A meeting of the joint Technical Advisory Committee (TAC) of the Shingle Creek and West Mississippi Watershed Management Commissions is scheduled for 11:30 a.m., Thursday, September 12, 2019, at Edinburgh USA, 8700 Edinbrook Crossing, Brooklyn Park, MN, immediately preceding the Commissions' regular meeting and public hearing.

Technical Memo

Subject: Potential Partnership Cost Share Item: Mallard Creek

Figure 2. The proposed aeration system.

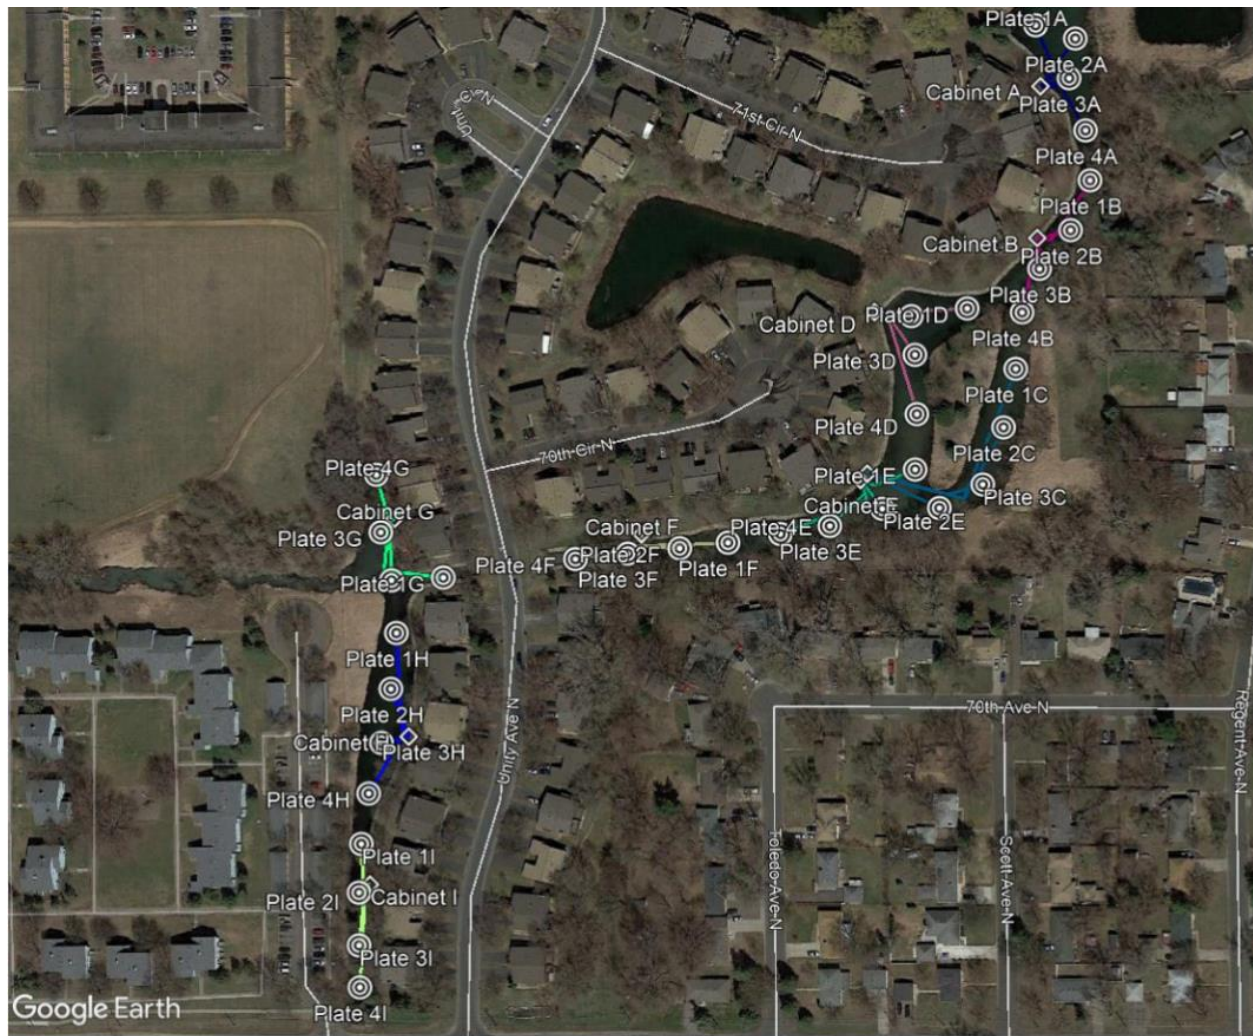
The City recently received a request from one of the associations as to whether a proposed aeration system would qualify for any cost-share funds. They forwarded quotes from an equipment supplier and an electrician to install a series of aerators in the channel in the southern part of the development (Figure 2). These total about \$78,000. The association also submitted a quote for algaecide at \$3,800. Some academic research was also provided.

We have reviewed the literature and the proposal and believe that such an aeration system may help reduce algal growth and muck, but it will not improve water quality or decrease any nutrient load being discharged into Shingle Creek downstream. It is our opinion that sharing in the cost of this system would not be consistent with the Partnership Cost Share guidelines, but would be happy to discuss further.
